Waterlow Park Trust

Re Archway Campus development

Topography of Highgate Hill showing Waterlow Park with illustrated viewpoints of Archway Campus tower which would reach about 160m (about 25 meters above the highest point in Highgate)

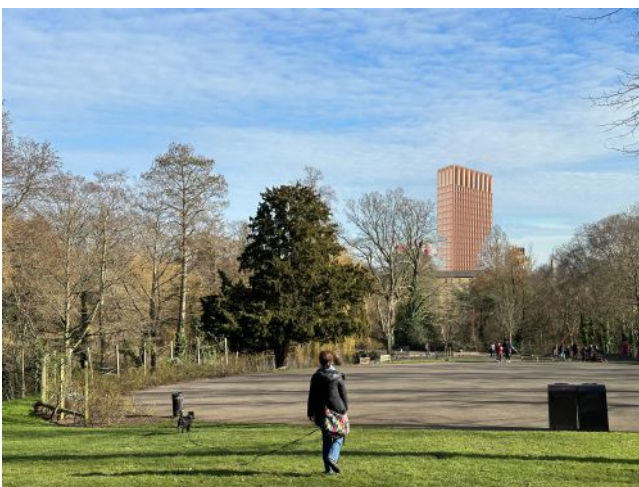
Views across the park from two positions around 700 meters from the proposed tower give an impression of the change to the skyline that any development of this scale would have.* We estimate that the tower will rise some 60 meters above these positions. Inevitably with such a new structure the relationship of Park to built environment would be radically altered. Instead of the distance from the park to taller buildings of London being such that there is still a real sense of being 'above' the city, the relationship would change to becoming a 'city centre' park 'beneath' the built environment of London. Waterlow Park would be dominated by the tower, overlooked for the first time ever from the south.

*We would welcome sight at the earliest opportunity of your own impact assessments of views, and trust that the two vantage points we have illustrated above will be represented with a higher degree of accuracy than in these approximations. Please provide methodology and calculations that demonstrate accuracy when preparing such assessments.
